Meadow Brook Elementary School

Town of East Longmeadow

ADA Transition Plan

September 2025

Figure 1: In the following image, the yellow lines show approximate routes to connect the baseball and soccer fields, along with the team seating areas associated with each field, to the nearest accessible routes from each parking lot.

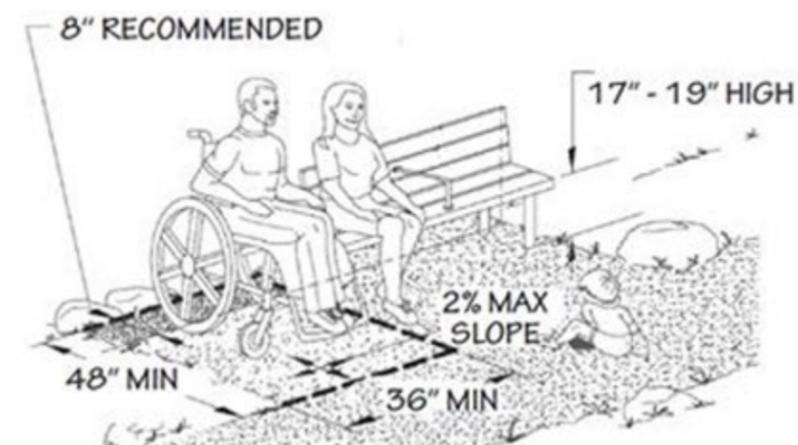
Accessibility issues include a lack of an accessible route to the baseball and soccer fields.

Additional accessibility issues at the baseball and soccer fields include lack of accessible team seating spaces.

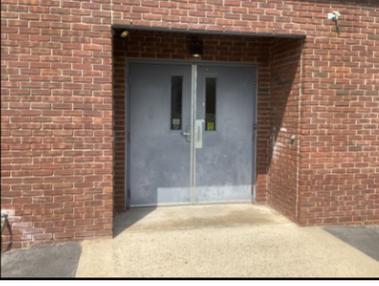
- Recommend, when a curb ramp is provided at the crosswalk along Porter Road, providing a detectable warning so that they are provided on both sides of the crosswalk.
- Recommend providing blade signage at classrooms with a non-glare finish, with characters that have a high contrast to the background.
- Recommend providing compliant designation signage at the boys' and girls' multi-user toilet rooms in all Pre-K and Grade 1 classrooms.
- Recommend providing color contrast between the wall and floor tiles in the nurse office single-user toilet room when the toilet room is renovated.
- Recommend providing a 36" min. by 48" min. stable, firm and slip-resistant surface adjacent to at least one bench in each area where benches are provided positioned to allow a person in a wheeled mobility device and a person sitting on the bench to have their shoulders aligned.

The following illustration demonstrates how to incorporate a 36" min. by 48" min. stable, firm and slip-resistant surface adjacent to at least one bench in each area where benches are provided positioned to allow a person in a wheeled mobility device and a person sitting on the bench to have their shoulders aligned.
